STAFF REPORT OF THE CITY'S ZONING ADMINISTRATOR
APPLICATION FOR ADMINISTRATIVE MODIFICATION

BZA 25-05-001
HEARING DATE: MAY 22, 2025

LOCATION: 2030 Barracks Road
TAX MAP & PARCEL: 010005000
APPLICANT: Kelsey Schlein
ZONING & USE: R-B (Residential)

Administrative Modification Request for Meadowbrook Multifamily Build-to-width Requirements

**Meadowbrook Multifamily
 Build-to-width Exhibit**

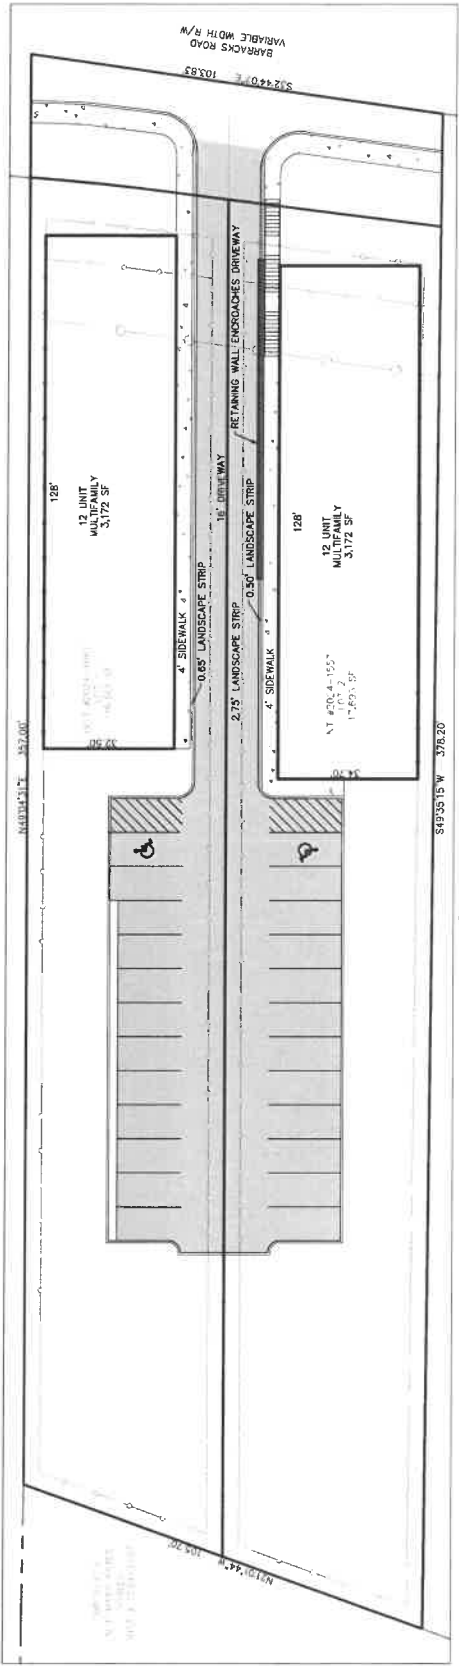
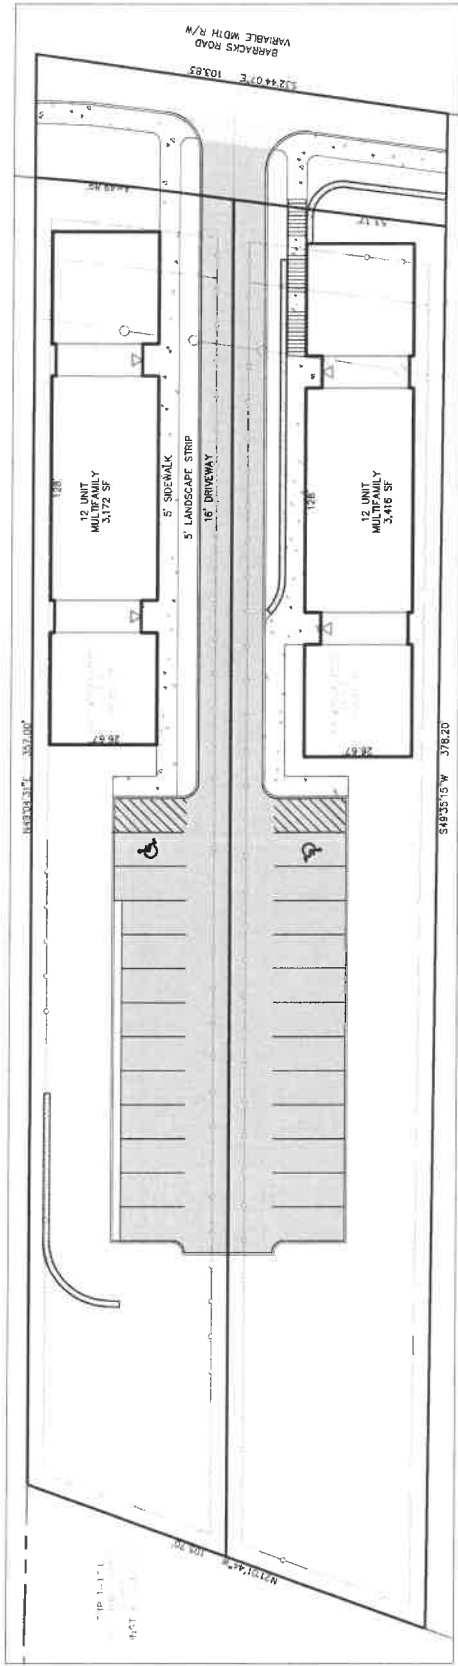
usable for expanding our building widths. As shown with the attached exhibit, by expanding the building widths, the sidewalks would need to be reduced down to four-foot-wide sidewalks and there becomes no usable place to provide landscaping. The lack of landscape space would hinder the landscaping intent of creating an attractive community and would impact the quality of life for future residents. The modification will not negatively affect adjacent properties or the ability to satisfy the remaining zoning R-B requirements.
